Gachsaran Polymer Industries Company	Gachsaran Polymer Industries Company HDPE Plant		
	General Arrangement Drawing (2D) (*Tie-In Points , Skid Dimensions & Orientation, Including Instrument, Junction Box and Local Panel Location Layout & Instrument Cable routing.) for Refrigerator Package	 	
PO No.: GPIC-PT-MA-PO-000-3029	Document Number: VD-GPIC-MA-3029-3029-0062	Rev. 02	Page 1 of 11

General Arrangement Drawing (2D) (*Tie-In Points , Skid Dimensions & Orientation, Including Instrument, Junction Box and Local Panel Location Layout & Instrument Cable routing.) for Refrigerator Package

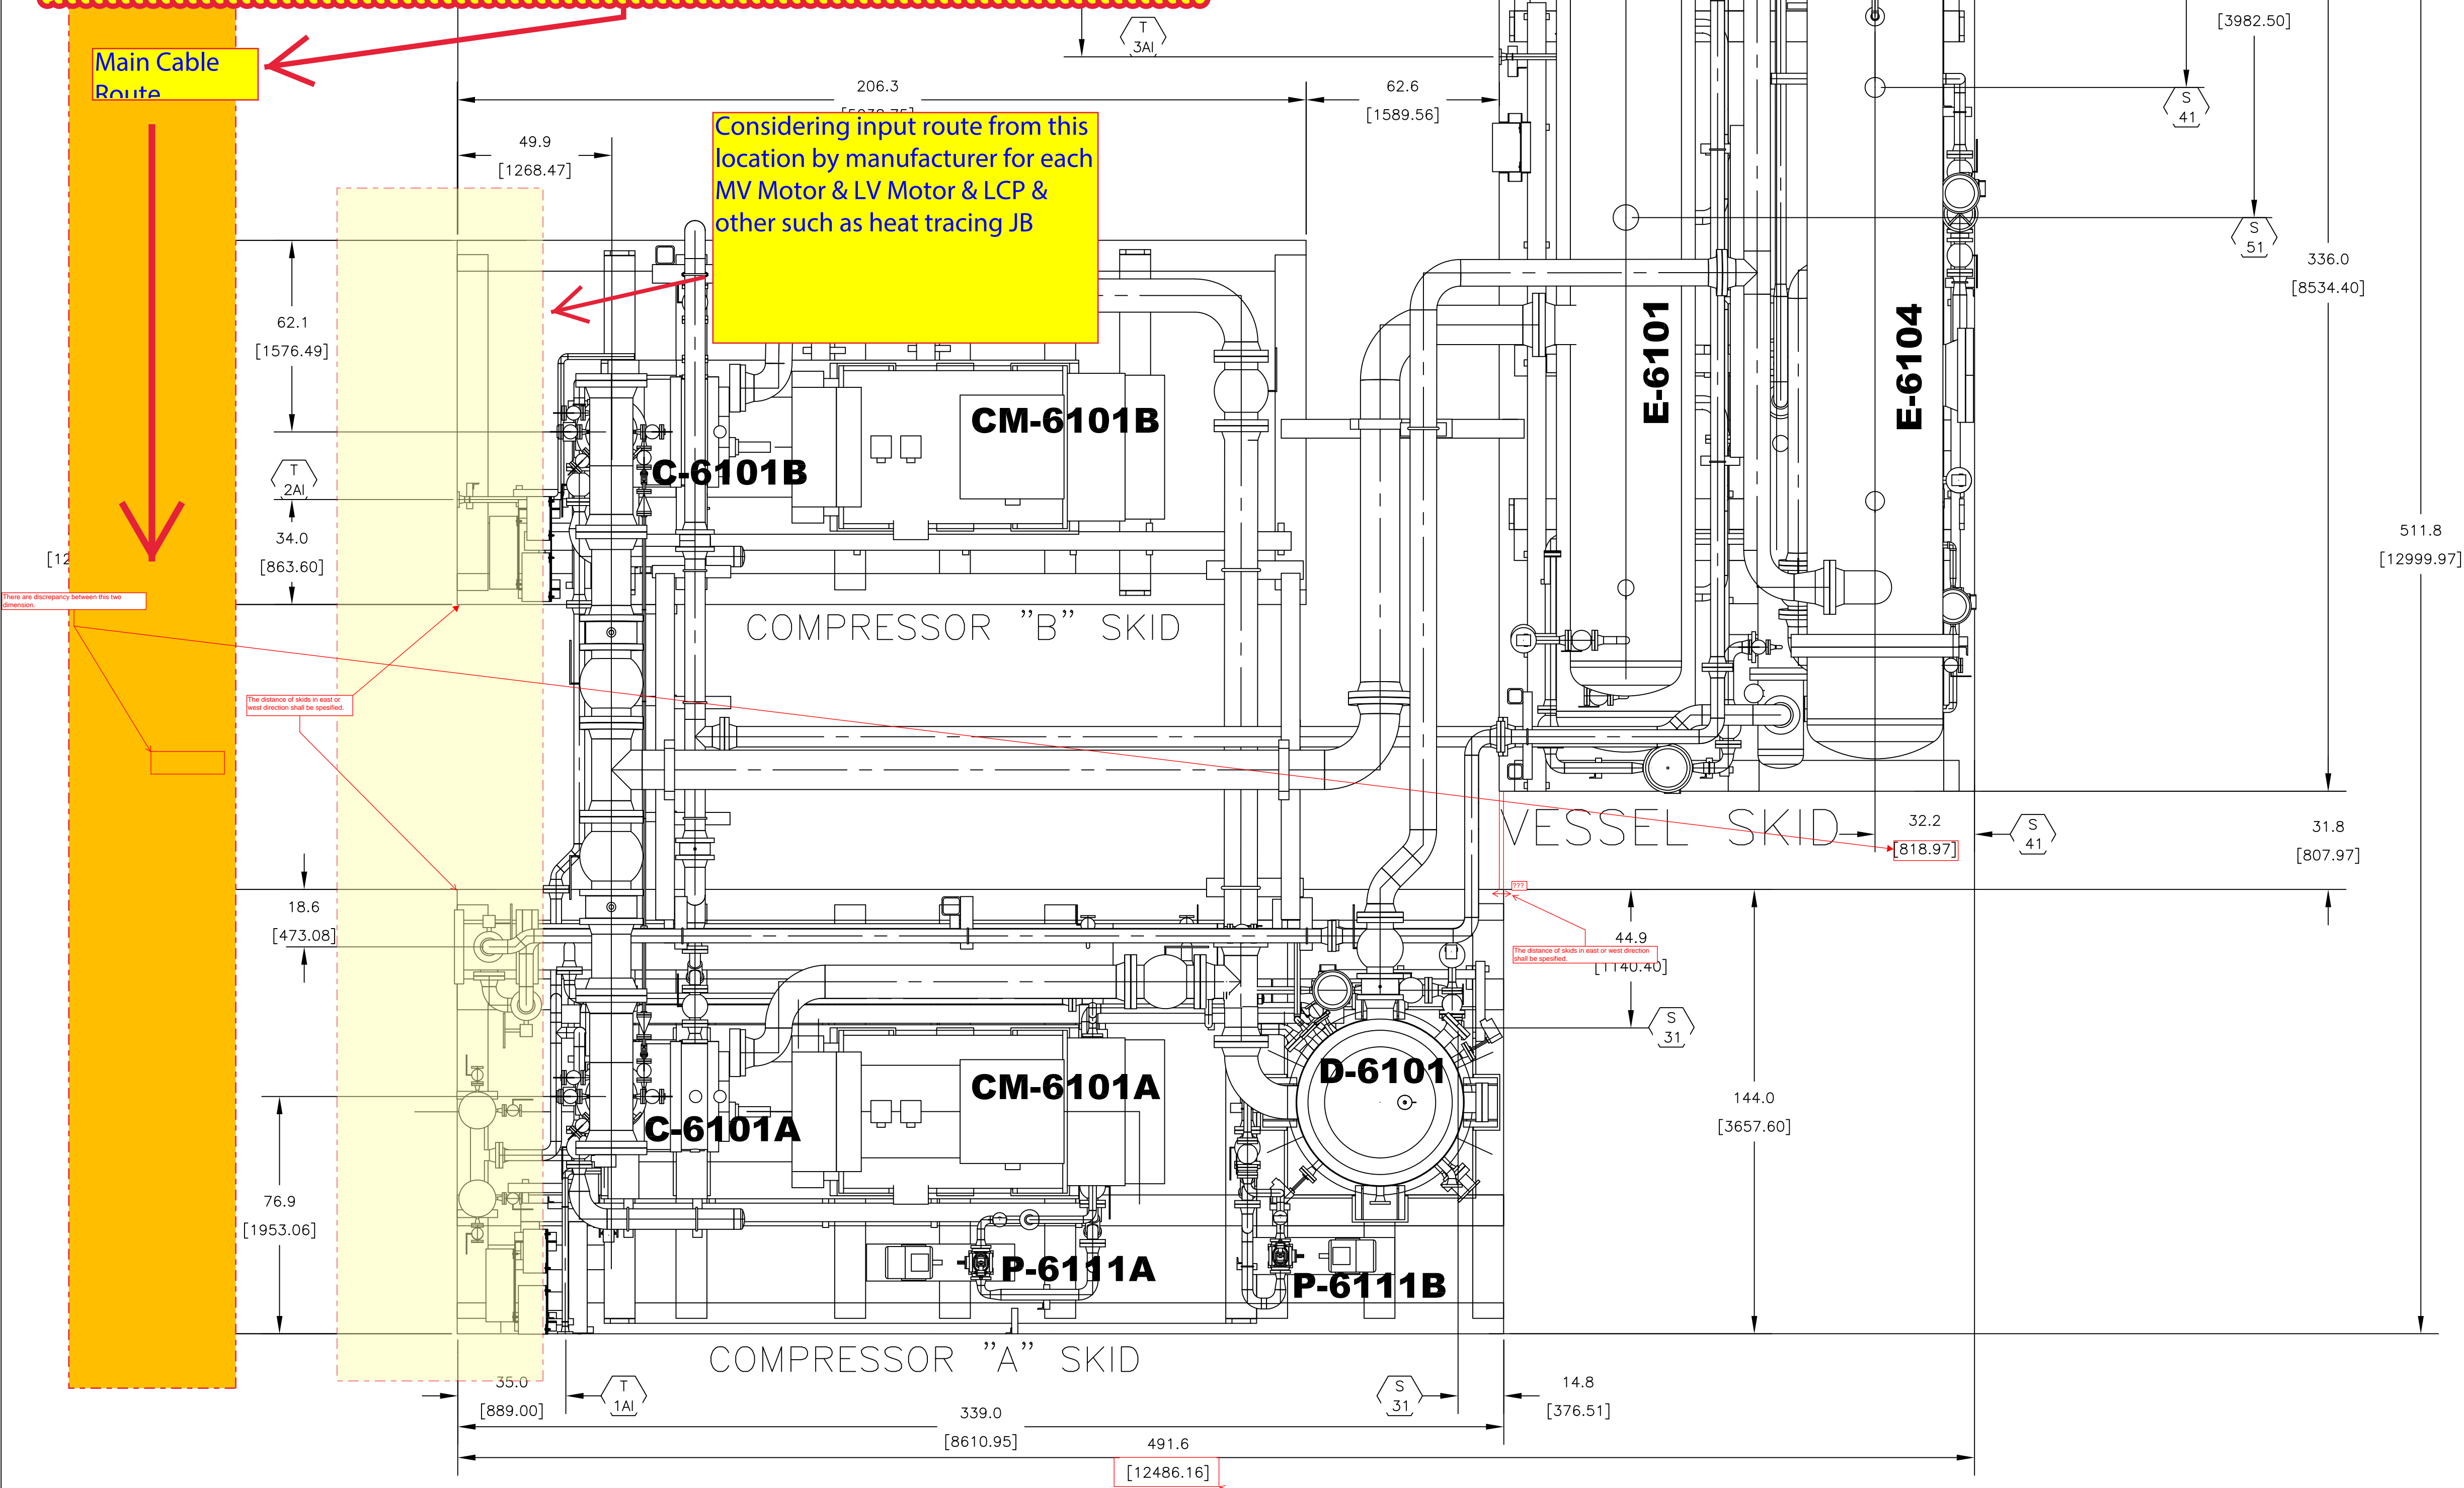
EL-3

The incoming power and control cables enter from the top of the package. According to the Material Requisition, the vendor shall consider, supply, and install the required cable trays, and clearly show the routing within the package boundary for all internal cabling. The routing of power cables up to the motor terminal boxes (LV/MV) shall be separated, and there shall be no interference or crossing between low-voltage and medium-voltage cable routes. In addition, LCP cable routes shall be completely independent from other cabling systems. All welding, supporting structures, and installation works inside the package — such as cable trays and earthing connections — shall be carried out by the manufacturer. No action will be required from the client at site for this purpose.

Considering input route from this location by manufacturer for each MV Motor & LV Motor & LCP & other such as heat tracing JB

IN-01. In addition to GA, this document is cable route and for cable route, symbol for instrument cable tray/ladder/conduit/JB shall be specified clearly and related cable route shall be shown in the drawing.
 IN-02 Tag number of all JB and LCP shall be added to this drawing. For tag number of JB, please refer to our comments on IO list.
 IN-03. Width/depth/size of trays/ladders/conduits shall be added and shown in this drawing.

PI COMMENT:
 The customer (EIED) shall provide with the STP and navies file of model. The all of TI in/out shall be specified in all views. The S-44,43,42,T-4A1 tags shall be specified in all of views. The distance between skids in north and east direction shall be specified in plan view, for example the distance between vessel skid and compressor skid in the east or west direction shall be specified in plan view.

This dimension has discrepancy with total length of skids. See per given drawing total length of skids is 11248.60

FRONT VIEW

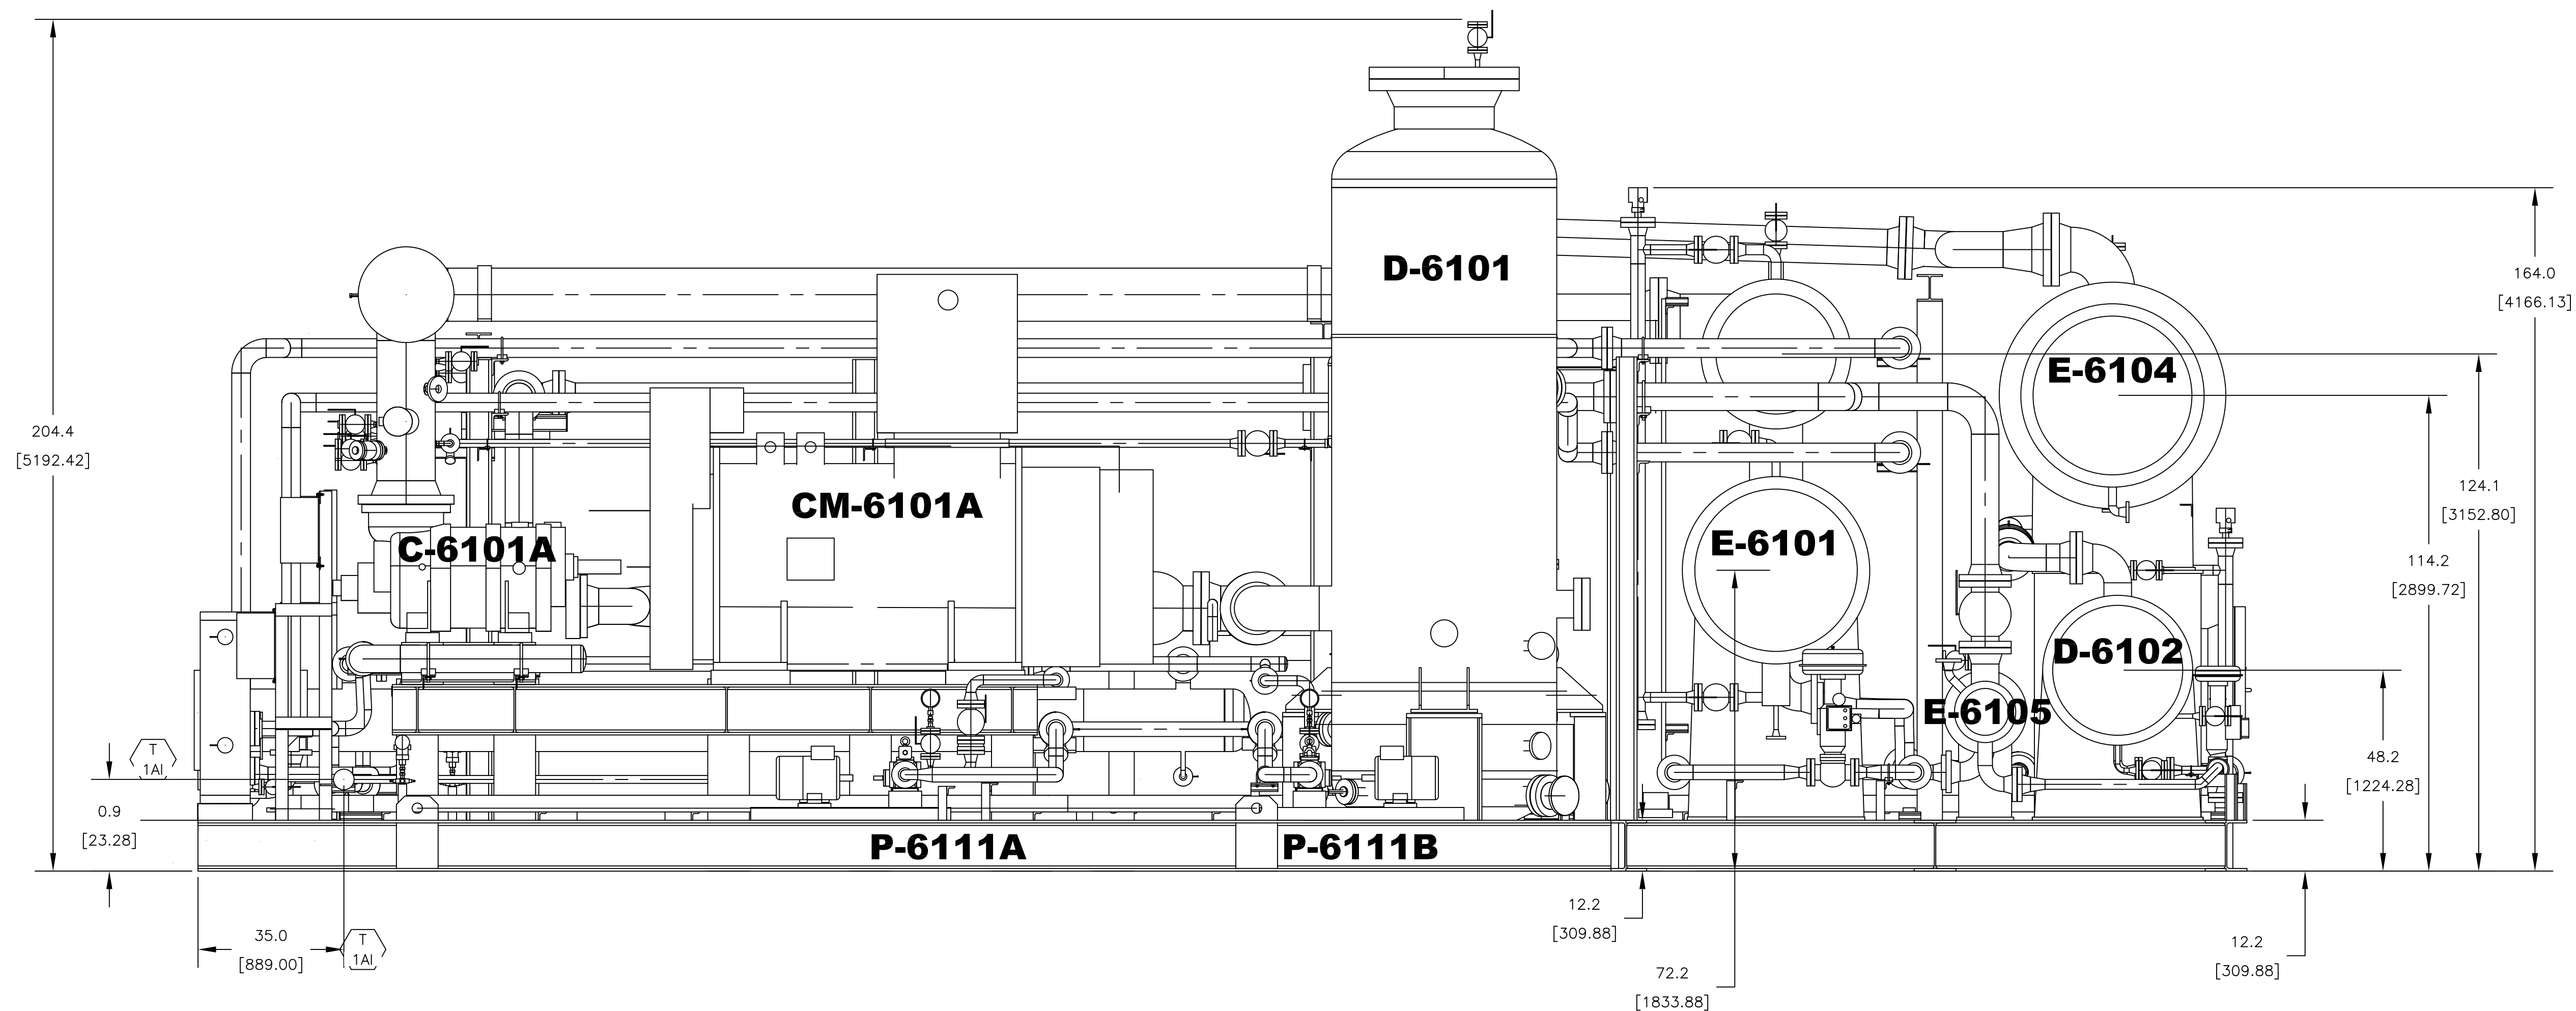
The all of tags (TI) must be specified in this view

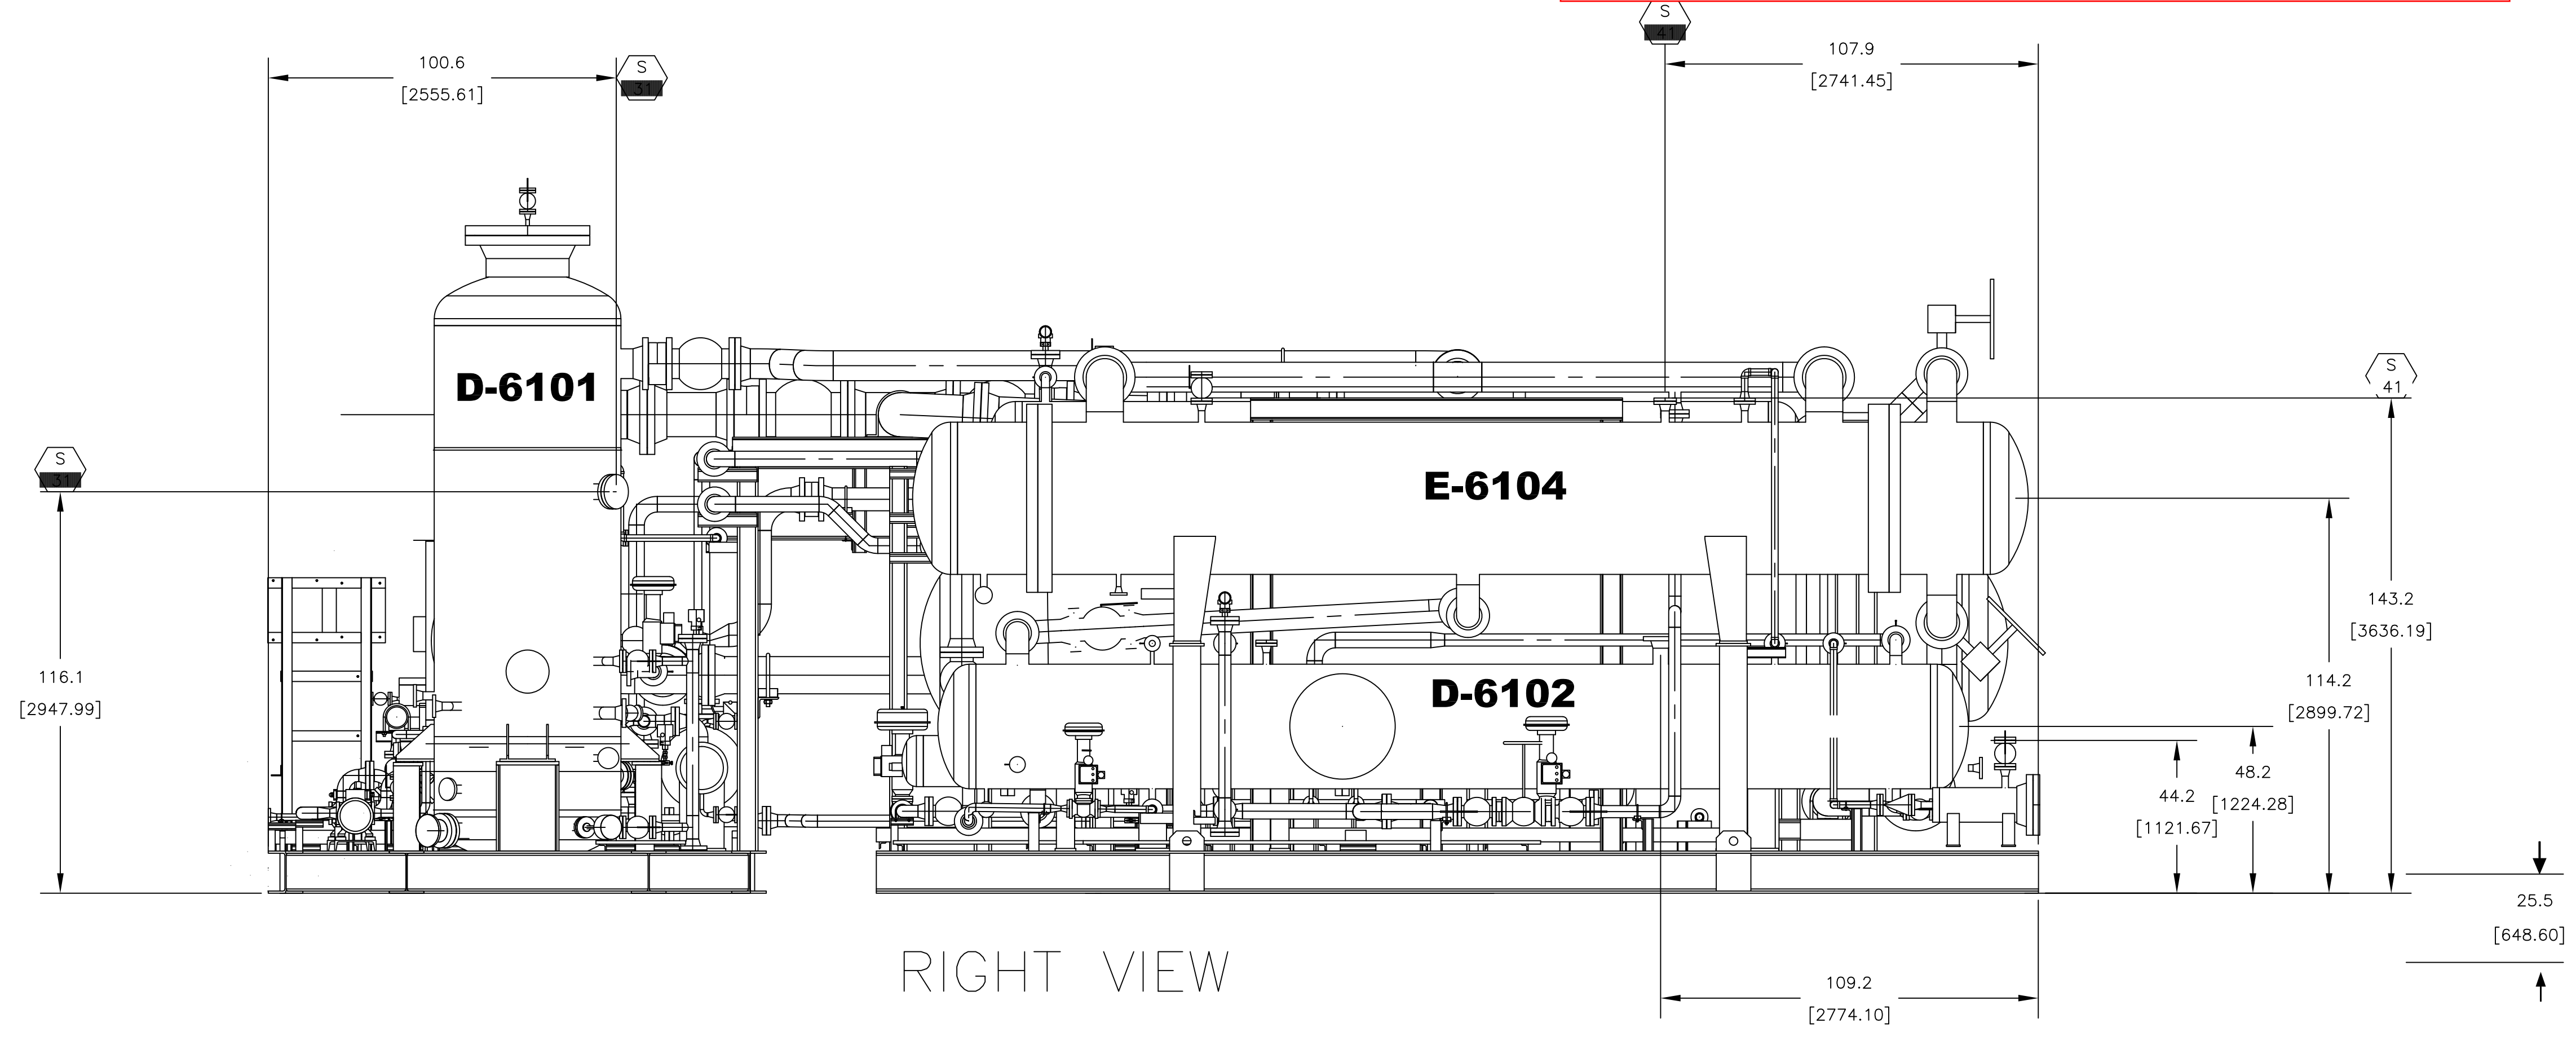
PR-01: PLEASE ADD OIL FILTER AND FILTER DRYER

EL01 (Repeated):
 1) Local Panel and junction boxes shall be numbered and displayed in a table with tags.
 2) All earth lugs shall be clearly identified.
 Moreover, an earth bar shall be installed on the skid, and all equipment earth conductors shall be connected to it.
 (These two items have been accepted in the vendor reply sheet but have not been implemented in this document.)

PR-02: IT CAN BE FINALIZED AFTER SIZING OF PSV INLETS

The size of tags (TI inlets) shall be specified in this view.
